SC Housing Accessibility Consultant Qualifications and Requirements

Nexus Vue Apartments
Spartanburg, SC

**RE: Accessibility Plan Review Report
Nexus Vue Apartments**
W. Blackstock Road & Morning Circle
Spartanburg, SC
Terracon Project Number F8226212

Re: **ACCESSIBILITY PLAN REVIEW REPORT**
Battery Park Senior Apartments
1 Battle Square
Asheville, North Carolina 28801
NCHFA Project Number TBD
Terracon Project Number F8216301

#1 - Parking

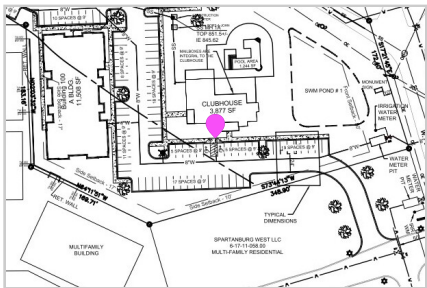
Emmanuel Belleau	Issue: Per a calculation of 2% of the total 440 parking spaces, it appears that a minimum of nine (9) accessible parking spaces should be provided. It appears that seven (7) are accounted for in the plans. Please review.	06 Mar 01:32 PM
Melissa Middleton	Issue: A van-accessible parking space did not appear to be delineated on the site plan near the Leasing Office. Please review.	04 Apr 01:59 PM

#16 - Drinking Fountain Height

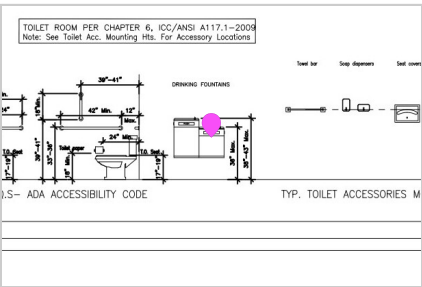
Melissa Middleton Issue: Provide the dimension for the minimum knee clearance at the low drinking fountain of 27". 14 Mar 03:50 PM

Plan: CH-A1.3 - TOILET PLAN & DETAILS | Location: Amenities Interior

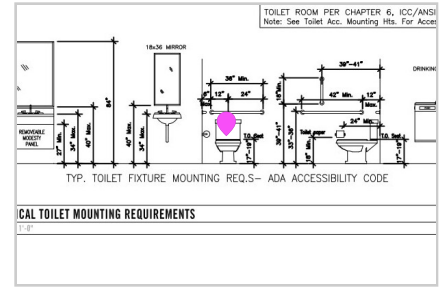
Issue: The location of the toilet is not noted in the details. Please provide.

● **#10 - Building 800: Curb Ramp**
Plan Review | Emmanuel Belleau | Site-Paths
Plan: CV-5 - Site Utility Plan | Location: Parking

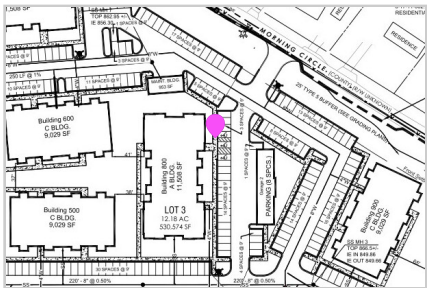
Task messages (time in EDT)
Emmanuel Belleau Issue: Missing curb ramp details at the accessible parking spaces.

#4 - Units A-2, B-6 & C-1 Type B

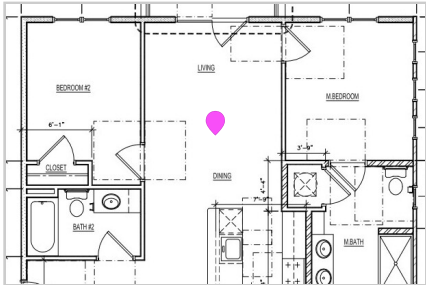
Emmanuel Belleau	Issue: Ensure electrical outlets in the kitchen are within 46" from finish floor. All other outlets should be a minimum of 15" from finish floor to the bottom outlet. All switches and thermostats should be a maximum of 48" from finish floor.	07 Mar 07:16 AM
Emmanuel Belleau	General Comment: Ensure that the toilet is centered 16" to 18" from the finish face of the adjacent wall.	07 Mar 07:17 AM
Emmanuel Belleau	Issue: Ensure that there is blocking provided around the toilets and showers or tubs to allow for installation of future grab bars, if needed.	07 Mar 07:20 AM
Emmanuel Belleau	General Comment: Ensure there is a low-profile threshold installed at the entrance to the apartment and either low-profile threshold or an adaptable threshold with a maximum 4" change in level installed at the patio.	07 Mar 08:01 AM
Emmanuel Belleau	Issue: Ensure that the kitchen will have a 40" maneuvering clearance between all opposing base cabinets, countertops, appliances, and walls. Minimum dimensions are recommended at the kitchen island.	04 Apr 02:16 PM

Plan: A2.2a - BUILDING 100 - FLOOR PLAN UNIT B-6 TYPE A

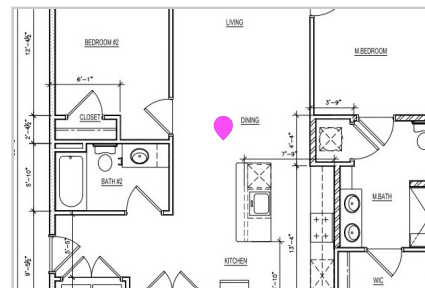
Emmanuel Belleau	Issue: Toilet paper dispenser should be installed 7" to 9" from the front of the toilet.	06 Mar 01:52 PM
Emmanuel Belleau	General Comment: Ensure that the toilet is centered 16" to 18" from the finish face of the adjacent wall.	06 Mar 01:53 PM
Emmanuel Belleau	Issue: Provide elevations for the blocking to be installed near the toilet, tub and/or shower.	06 Mar 02:04 PM
Emmanuel Belleau	Issue: Ensure that the pantry depth is no more than 24" from the the face of the exterior wall to the back of the pantry.	06 Mar 02:11 PM
Emmanuel Belleau	Issue: All work surfaces and sinks should be within 34" from finish floor, this includes the kitchen sink and bathroom lavatory. The cabinets and sinks should allow for a 27" knee clearance.	06 Mar 02:25 PM
Emmanuel Belleau	Issue: Ensure the electrical outlets in the kitchen are within 44" from finish floor. All other outlets should be a minimum of 15" from finish floor to the bottom outlet. All switches and controls for the thermostats should be a maximum of 48" from finish floor.	06 Mar 02:54 PM

Emmanuel Belleau	General Comment: Ensure there is a low-profile threshold installed at the entrance to the apartment as well as at the patio.	07 Mar 06:53 AM
Emmanuel Belleau	Issue: Ensure that the shelves within the closets have a reach range within 15" to 48" from the finish floor.	07 Mar 07:34 AM
Emmanuel Belleau	Issue: The electrical panel should be installed a maximum of 48" from finish floor to the top breaker.	07 Mar 07:37 AM
Emmanuel Belleau	Issue: It is unclear if the washer and dryer are either top- or front-loading. Confirm the clear floor space at each appliance either centered on a top-loading appliance or offset on a front-loading appliance.	04 Apr 02:47 PM
Emmanuel Belleau	Issue: Ensure that the kitchen will have a 40" maneuvering clearance between all opposing base cabinets, countertops, appliances, and walls. Minimum required dimensions are recommended at the kitchen island.	04 Apr 03:16 PM

Emmanuel Belleau	Issue: Provide elevations for the blocking to be installed near the toilet, tub and/or shower.	04 Apr 04:02 PM

#7 - Unit A-2 Type A

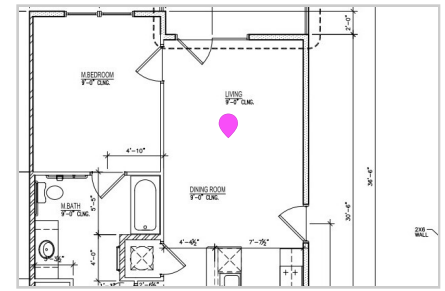
Emmanuel Belleau	Issue: Ensure that the shelves within the closets, have a reach range within 15" to 48" from the finish floor.	07 Mar 09:38 AM
Emmanuel Belleau	General Comment: Ensure there is a low-profile threshold installed at the entrance to the apartment as well as at the patio.	07 Mar 09:38 AM
Emmanuel Belleau	Issue: The washer and dryer appear to be stackable and assumed to be beyond the allowable reach range. Please review the laundry area, whether top- or front-loading equipment is being installed and the clear floor area to access the appliances.	07 Mar 09:38 AM
Emmanuel Belleau	Issue: The electrical panel should be installed a maximum of 48" from the finish floor to the top breaker.	07 Mar 09:39 AM

#5 - Unit C-1 Type A

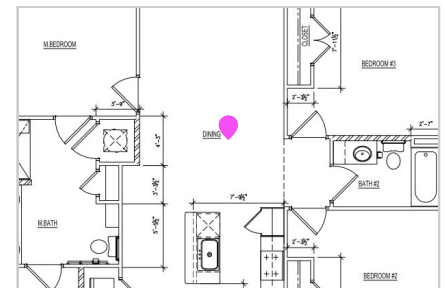
Emmanuel Belleau	General Comment: Ensure there is a low-profile threshold installed at the entrance to the apartment as well as at the patio.	07 Mar 08:54 AM
Emmanuel Belleau	Issue: Provide elevations for the blocking to be installed near the toilet, tub and/or shower.	04 Apr 02:52 PM

Plan Review | Emmanuel Belleau | Unit-Mobility
Plan: P1.1 - BUILDING TYPE A FIRST FLOOR PLUMBING PLAN | Location: Unit C - 1 Type A

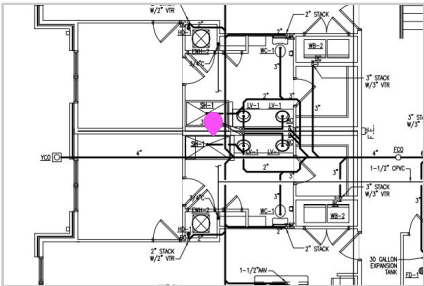
Melissa Middleton	Issue: Confirm the location of the shower controls in the roll-in shower. From the architectural unit plan, a seat appears to be provided; therefore, the controls should be on the back wall near the seat within 27" of the seat wall. Please review.	04 Apr 02:34 PM
-------------------	---	-----------------

● #29 - Emergency Pull Cords

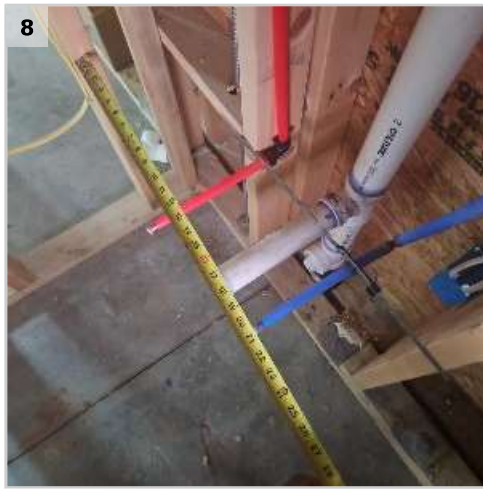
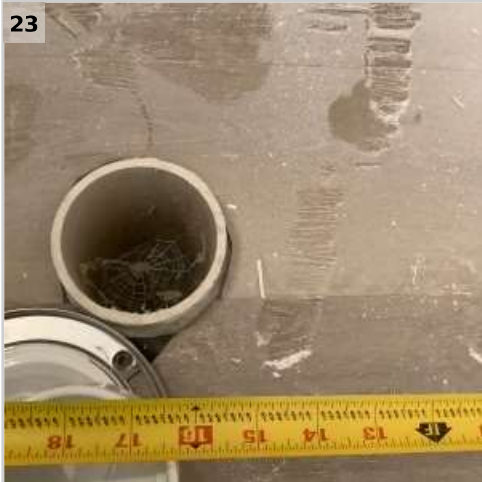
Melissa Middleton	Issue: All mobility and hearing and sight-impaired units must have a wireless or hard-wired emergency alert system installed, including a pull cord located in every bedroom and bathroom that either triggers an audible and visual notification outside of the dwelling unit or notifies the staff and 911 during work hours, and 911 after work hours. Provide information on the emergency pull cords.	05 Jan 09:54 PM
-------------------	--	-----------------

● **#21 - Myrtle Mobility Unit #2101**
Field Issue | Emmanuel Belleau | Unit-Mobility
Plan: A1.1_101 - Apartment 10 Plan | Location: Unit 2x2 HCS
Tags: #mobility

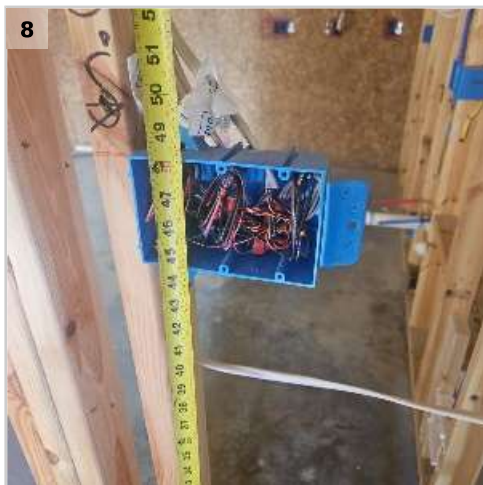
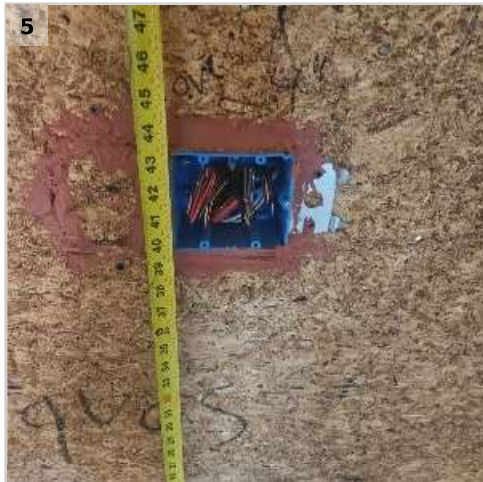
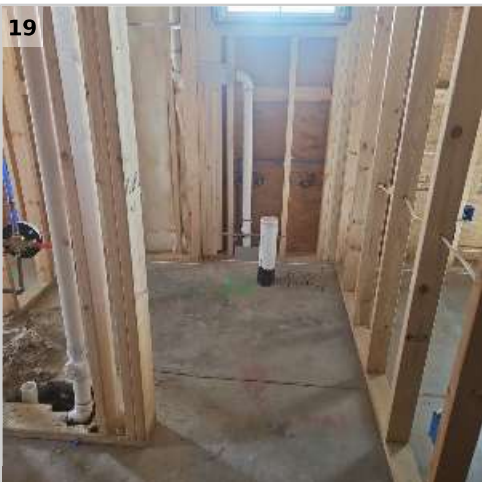
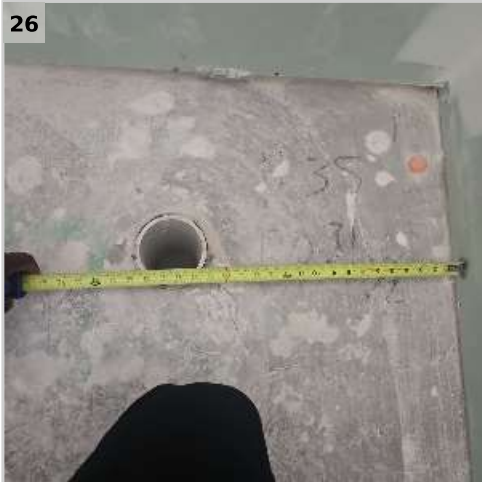
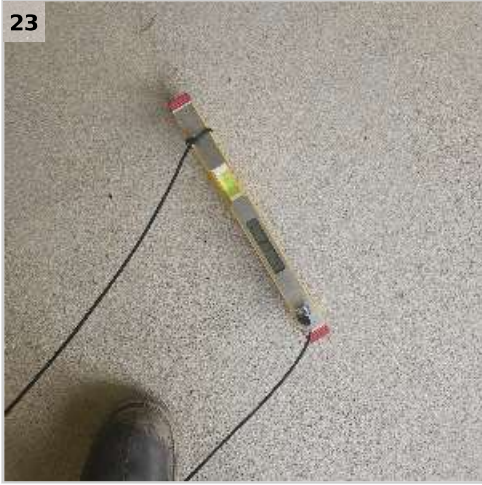
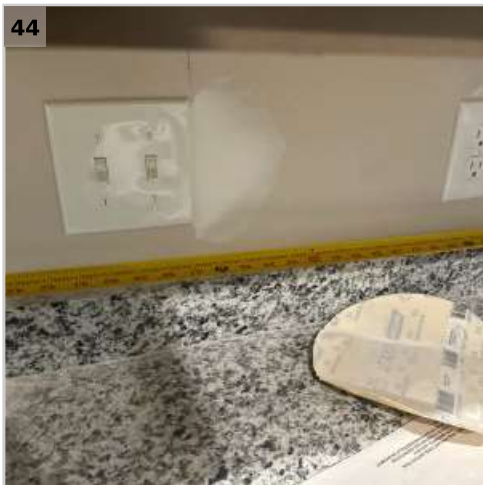
Emmanuel Belleau	Photo 14 - GPS: 32.9747767, -80.1400045	05 Jun 09:55 AM
Emmanuel Belleau	Issue from previous report: The toilet in the master bathroom and hallway bathroom should be centered 18" from the finish face of the adjacent wall once installed. The toilet drain in the master bathroom is currently centered approximately 16-5/8" from the adjacent wall. Update 10/9/24: No change. Update 12/26/24: No change.	05 Jun 09:57 AM
Emmanuel Belleau	Photo 15 - GPS: 32.9746658, -80.139344	05 Jun 09:57 AM
Emmanuel Belleau	Issue: Ensure the shower controls will be within 27" from the seat wall once installed. Item Closed - 10/9/24	05 Jun 09:57 AM
Emmanuel Belleau	Issue from previous report: Ensure the shower threshold will not exceed a 1/2" level change. ITEM CLOSED 12/26/2024	05 Jun 09:57 AM
Emmanuel Belleau	Photo 16 - GPS: 32.9749366, -80.1398023	05 Jun 09:57 AM
Emmanuel Belleau	Photo 17 - GPS: 32.9746743, -80.1400697	05 Jun 09:58 AM

● **#17 - Willow Mobility Unit #4104**

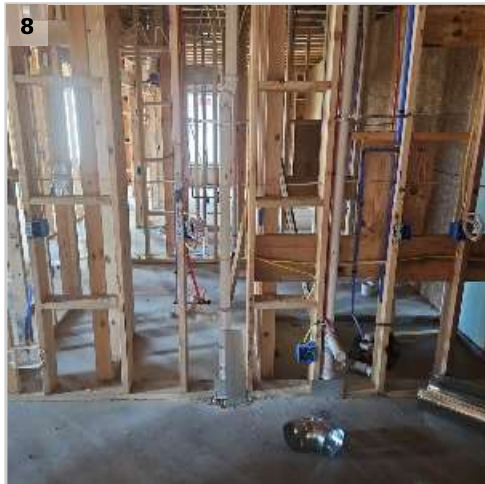
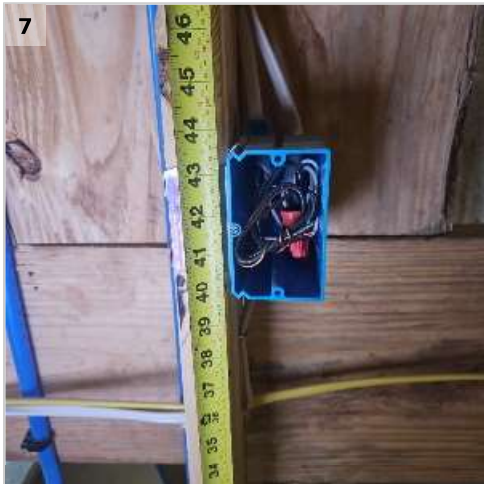
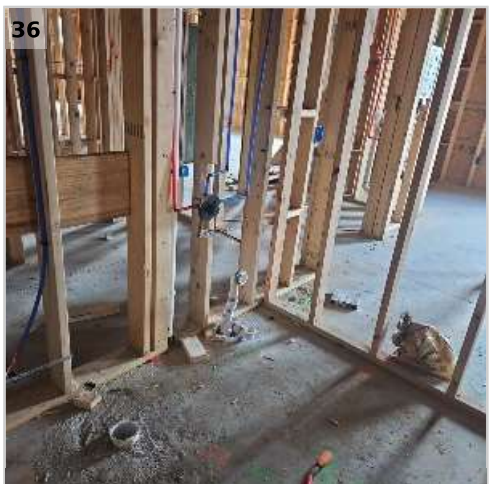
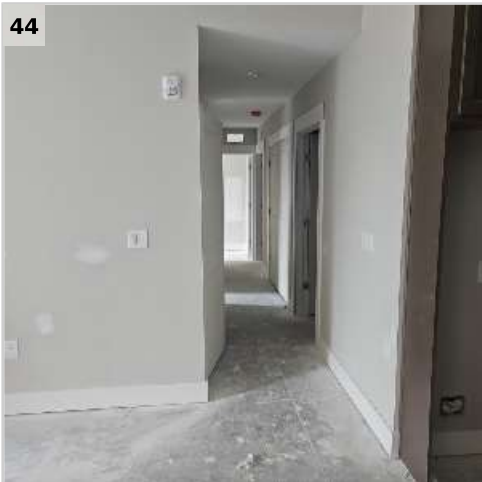
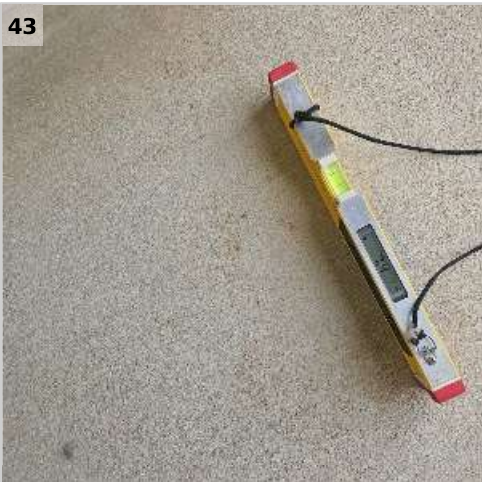
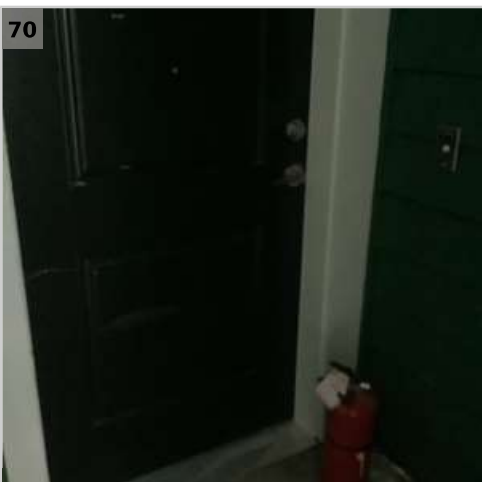
Emmanuel Belleau	Photo 26 - GPS: 32.974324, -80.1396881	05 Jun 09:13 AM
Emmanuel Belleau	Issue from previous report: Ensure the toilets will be centered 18" from the finish face of the adjacent wall once installed. Update 10/9/24: No change. ITEM CLOSED 12/26/2024	05 Jun 09:14 AM
Emmanuel Belleau	Photo 27	05 Jun 09:14 AM
Emmanuel Belleau	Issue: Ensure the shower controls will be within 27" from the seat wall. Item Closed - 10/9/24	05 Jun 09:15 AM
Emmanuel Belleau	Issue: Ensure the shower threshold will not exceed a 1/2" level change. Item Closed - 10/9/24	05 Jun 09:15 AM
Emmanuel Belleau	Photo 28	05 Jun 09:15 AM
Emmanuel Belleau	Photo 29 - GPS: 32.9736333, -80.1403066	05 Jun 09:15 AM
Emmanuel Belleau	Photo 30 - GPS: 32.9736333, -80.1403066	05 Jun 09:15 AM
Emmanuel Belleau	Photo 31 - GPS: 32.9736333, -80.1403066	05 Jun 09:16 AM
Emmanuel Belleau	Photo 32 - GPS: 32.9736333, -80.1403066	05 Jun 09:16 AM

Emmanuel Belleau	Photo 33 - GPS: 32.9741867, -80.1397836	05 Jun 09:16 AM
Emmanuel Belleau	Photo 34 - GPS: 32.9741556, -80.1398712	05 Jun 09:17 AM
Emmanuel Belleau	Issue: The master bathroom door will not provide the minimum 31-5/8" clear width. The plans show that a 32" door will be provided. The door should be a minimum 34" wide door. Item Closed - 10/9/24	05 Jun 09:19 AM
Emmanuel Belleau	Photo 35 - GPS: 32.973555, -80.1400468	05 Jun 09:19 AM
Emmanuel Belleau	Photo 36 - GPS: 32.973555, -80.1400468	05 Jun 09:19 AM
Emmanuel Belleau	Photo 37 - GPS: 32.9741524, -80.1397158	05 Jun 09:20 AM
Emmanuel Belleau	Photo 38 - GPS: 32.9741692, -80.1398888	05 Jun 09:20 AM
Emmanuel Belleau	Photo 39 - GPS: 32.9741943, -80.1398936	05 Jun 09:20 AM
Emmanuel Belleau	Photo 40 - GPS: 32.9741813, -80.1398904	05 Jun 09:21 AM
Emmanuel Belleau	Photo 41 - GPS: 32.9741813, -80.1398904	05 Jun 09:21 AM
Emmanuel Belleau	Issue: Ensure the back bedroom will have a minimum of 48" from the face of the finish entry wall to the finish face of the closet wall. The current framed space is 48" from the door stud to the closet wall stud. Item Closed - 10/9/24	05 Jun 09:25 AM

● #13 - Myrtle Sensory Unit #3101

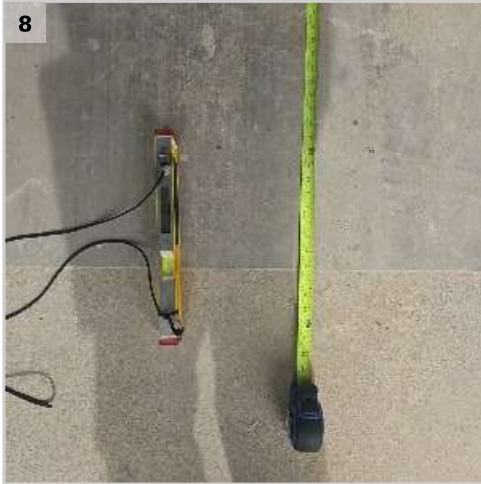
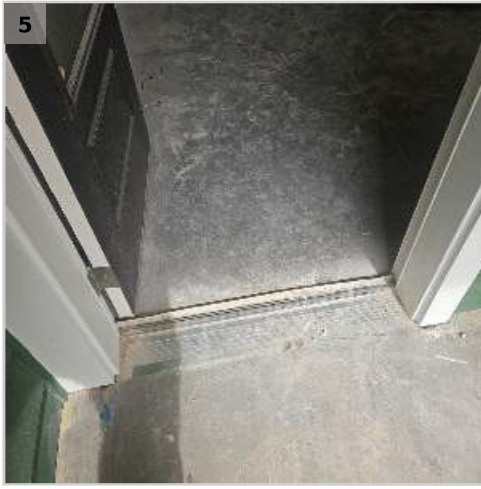
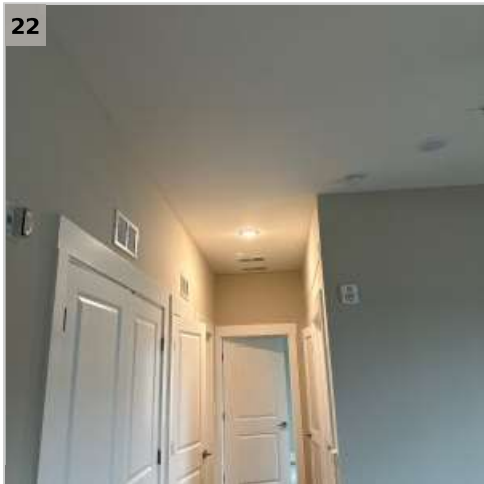
Emmanuel Belleau	Issue: Please verify that there will be sensory equipment installed in this unit. Update 10/9/24: This is the designated sensory unit. Compliant sensory equipment was not installed during our visit. ITEM CLOSED 12/26/2024	05 Jun 10:28 AM
Emmanuel Belleau	Issue from previous report: Ensure the toilet in the master bathroom and hallway bathroom will be centered 18" from the finish face of the adjacent wall once installed. Update 10/9/24: The toilet is not centered 18" from the finish face of the adjacent wall. ITEM CLOSED 12/26/2024	07 Jun 07:46 AM
Emmanuel Belleau	Photo 1 - GPS: 32.974315, -80.1409626	09 Oct 10:45 AM
Emmanuel Belleau	Photo 2 - GPS: 32.974315, -80.1409626	09 Oct 10:45 AM
Emmanuel Belleau	Photo 3 - GPS: 32.974315, -80.1409626	09 Oct 10:45 AM
Emmanuel Belleau	Photo 4	09 Oct 10:46 AM
Emmanuel Belleau	Photo 5 - GPS: 32.9736055, -80.1402389	09 Oct 10:46 AM
Emmanuel Belleau	Photo 6 - GPS: 32.9736055, -80.1402389	09 Oct 10:47 AM

Emmanuel Belleau	Issue: Ensure there will be a minimum of 40" clear between the refrigerator and opposing countertops. The kitchen island would need to be modified to provide approximately an additional 12" in front of the refrigerator. ITEM CLOSED 12/26/2024	11 Oct 11:04 AM

Plan Review | Katie Rich | Restroom-Common
Plan: A.401 - INTERIOR ELEVATIONS | Location: Amenities

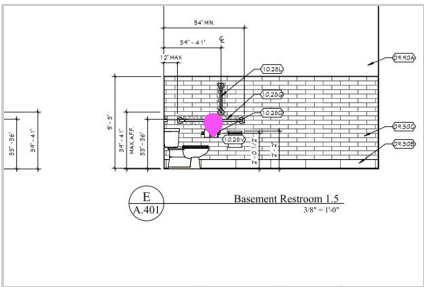
Katie Rich	Issue: The toilet paper dispenser should be located 7" to 9" forward from the lip of the toilet to the center of the dispenser. Please review all restrooms.	25 Mar 10:04 AM
------------	--	-----------------

Plan Review | Katie Rich | Restroom-Common
Plan: A.401 - INTERIOR ELEVATIONS | Location: Amenities

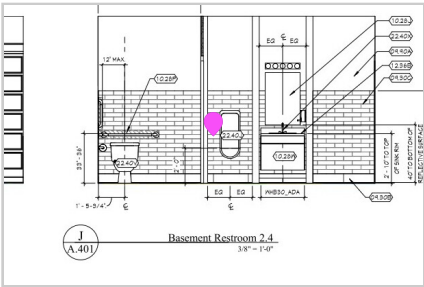
Katie Rich	Issue: Ensure that a minimum of 30" clearance is provided to access the urinal.	29 Mar 03:41 PM
------------	---	-----------------

Plan Review | Katie Rich | Restroom-Common
Plan: A.100 - BASEMENT PLAN | Location: Amenities

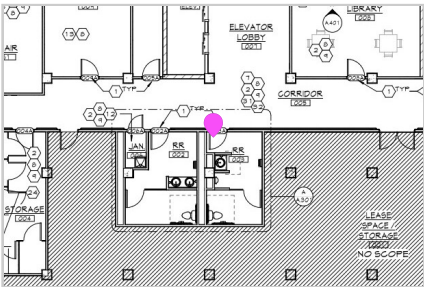
Melissa Middleton	Issue: The required door maneuvering clearance does not appear to be provided on the pull side of the door. A minimum of 48" is required between the door and opposing wall.	05 Apr 01:19 PM
-------------------	--	-----------------

Plan Review | Melissa Middleton | Restroom-Common
Plan: A.100 - BASEMENT PLAN | Location: Amenities

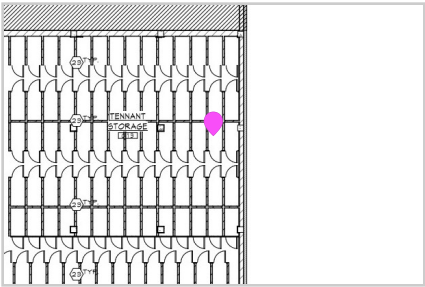
Melissa Middleton	Issue: There does not appear to be adequate maneuvering clearance in the tenant storage area for access.	05 Apr 01:25 PM
-------------------	--	-----------------

Plan Review | Katie Rich | Restroom-Common
Plan: A.102 - SECOND FLOOR PLAN | Location: Amenities

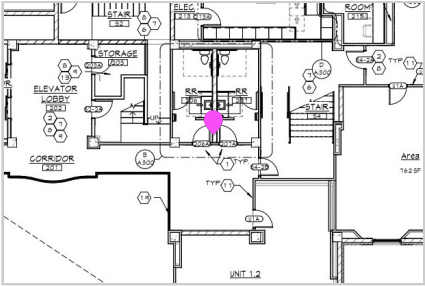
Melissa Middleton	Issue: The required door maneuvering clearance does not appear to be provided on the pull side of the door. A minimum of 48" is required between the door and opposing wall.	05 Apr 02:44 PM
-------------------	--	-----------------

Plan Review | Katie Rich | Unit-Mobility
Plan: A.359a - UNIT 1.10 ANSI TYPE A | Location: General

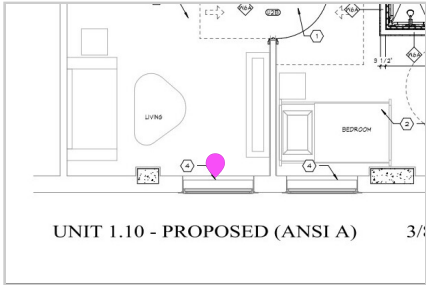
Hamid Dehghan Niri	Issue: Clarify and coordinate the window type. Operable parts should be accessible and within a reach range of 48" above finish floor in all rooms except the kitchen and bath in the designated accessible dwelling units. (No pinching, twisting and turning of the wrist to operate.)	24 Mar 06:19 PM
--------------------	--	-----------------

#19 - Mobility & Sensory Units: Emergency Pull Cord

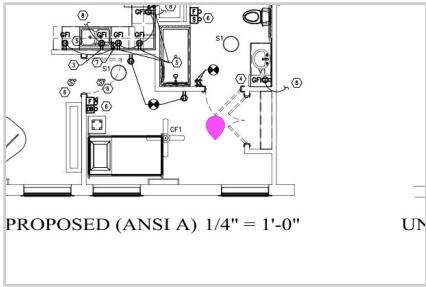
Task messages (time in EDT)
Katie Rich Issue: Emergency pull cords must be mounted no higher than 48 inches from the ground and the cord must be within 6" from the floor. 30 Mar 02:02 PM

#27 - Unit Electrical Panels

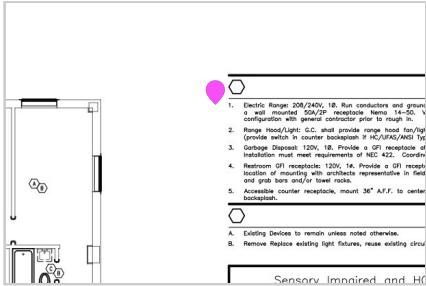
Task messages (time in EDT)
Melissa Middleton Issue: Per NCHFA, electrical panels in Type A and Type B units must be mounted at 48" maximum above finish floor to top breaker. 05 Apr 03:20 PM

#28 - Mobility Unit: Refrigerator

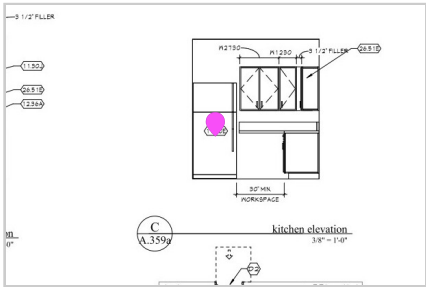
Task messages (time in EDT)
Melissa Middleton Issue: Per NCHFA, all accessible "Type A" units must have a side by side refrigerator or one with a bottom freezer drawer. The refrigerator doors must be able to open enough for storage bin removal. 05 Apr 03:24 PM

#29 - Mobility Unit: Cabinet Hardware

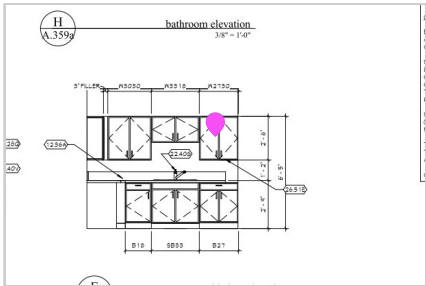
Task messages (time in EDT)
Melissa Middleton Per NCHFA for elderly properties, loop handles is required on all cabinets and drawers. 05 Apr 03:35 PM

Plan Review | Katie Rich | Unit-Mobility
Plan: A.359a - UNIT 1.10 ANSI TYPE A | Location: UNIT 1.10

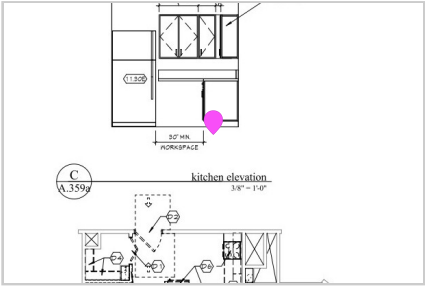
Katie Rich Issue: We recommend that the work surface be located adjacent to the range/oven. 04 Apr 03:07 PM

Plan Review | Katie Rich | Unit-Mobility
Plan: A.359a - UNIT 1.10 ANSI TYPE A | Location: UNIT 1.10

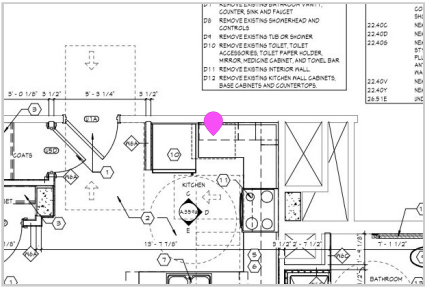
Katie Rich Issue: We recommend that the work surface be located adjacent to the range/oven. Per NCHFA, the switches for the range hood and light are to be located behind the work station which per the electrical plan is located to the right of the range. Coordinate the work surface area and the switches. 25 Mar 08:48 AM

Plan Review | Katie Rich | Unit-Mobility
Plan: A.359a - UNIT 1.10 ANSI TYPE A | Location: UNIT 1.10

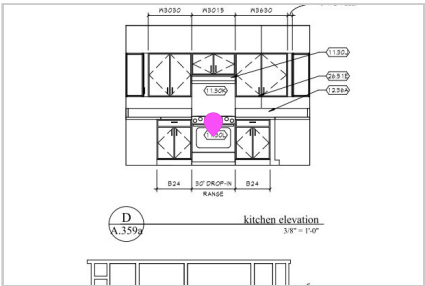
Katie Rich Issue: Mobility units must have controls located on the front of range. It is recommended that the same range type (11.30C) used in mobility Unit 2.4a is used in Unit 1.10. 25 Mar 09:49 AM

Plan: A.359a - UNIT 1.10 ANSI TYPE A | Location: UNIT 1.10

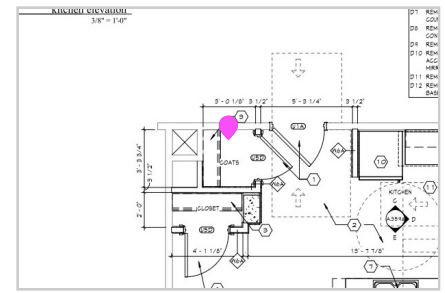
Katie Rich Issue: A maximum depth of 24" from outside face is allowed in the shallow closet if a 32" door clearance is not provided. The closet should be modified. 28 Mar 03:36 PM

Plan: A.103 - THIRD-TWELFTH FLOOR PLAN | Location: UNIT 1.10

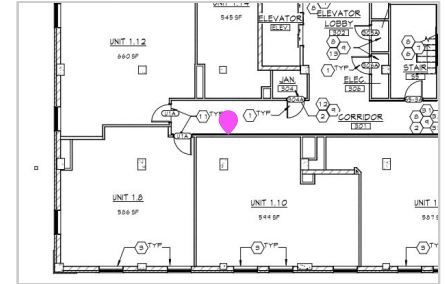
Katie Rich Issue: There is no door provided on the floor plans for this unit. 28 Mar 04:08 PM
